APPLICATION NO.	FILING DATE	FIRST NAMED INVENTOR	ATTORNEY DOCKET NO.	CONFIRMATION NO.
10/578,421	05/05/2006	Ki Ju Kang	P/4761-4	1653
2352 7590 02/05/2009 OSTROLENK FABER GERB & SOFFEN 1180 AVENUE OF THE AMERICAS NEW YORK, NY 100368403				
EXAMINER				
VESRA, DINESH K				
ART UNIT		PAPER NUMBER		
3633				
MAIL DATE		DELIVERY MODE		
02/05/2009		PAPER

### Office Action Summary

**DETAILED ACTION**

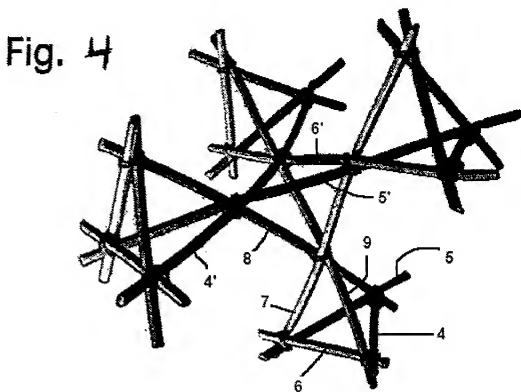
5. **Claims 1-6 are rejected under 35 U.S.C. 102(b) as being clearly anticipated by Snelson (US Patent Application Publication 2002/0081936 A1).** Snelson discloses a three-dimensional wire-woven cellular light structure (see Fig. 4 below) formed of six groups of orientational-continuous-wires intercrossed with each other at 60 degrees or 120 degrees of angles in a three-dimensional space, a unit cell of the cellular light structure comprising: a first regular tetrahedron member formed of a first to sixth wires, the first regular tetrahedron member being constructed in a such a manner that the first wire (4), the second wire (5), and the third wire (6) are intercrossed in a plane to form an equilateral triangle, the fourth wire (7) is intercrossed with the

intersection point of the second wire (5) and the third wire (6), the fifth wire (8) is intercrossed with the intersection point of the first wire (4) and the second wire (5), and the sixth wire (9) is intercrossed with the intersection point of the third wire (6) and the first wire (4), the fourth wire (7), the fifth wire (8), and the sixth wire (9) being intercrossed with one another at a single reference intersection point; and a second regular tetrahedron member contacted with the first regular tetrahedron member at the reference intersection point and having a similar shape to the first regular tetrahedron member, the second regular tetrahedron member being constructed in such a manner that the fourth wire (7), the fifth wire (8), and the sixth wire (9) pass the reference intersection point and extend further, each of a group of wires (4', 5', and 6') is intercrossed with the two wires selected from the extended fourth, fifth and sixth wires, the group of wires (4', 5' and 6') being in parallel with the first wire (4), the second wire (5), and the third wire (6) respectively; wherein the wires are intercrossed with each other at 60 degrees or 120 degrees, and the unit cell is repeated in a three-dimensional pattern, thereby forming a truss-type structure (though the reference does not specifically teach these angles, it does teach that the structures are tetrahedral, which inherently form these angles); wherein among the six groups of orientational-wires, three groups of orientational-wires forming a vertex of the first or second regular tetrahedron member are intercrossed clockwise or counterclockwise when seen from the front of the vertex (see Fig. 4); wherein the first and second regular tetrahedron members have a similarity ratio of 1:1 (see Fig. 4); wherein the first and second regular tetrahedron member have a ratio of similarity in the range of 1:1 to 1:10 (see Fig. 4);
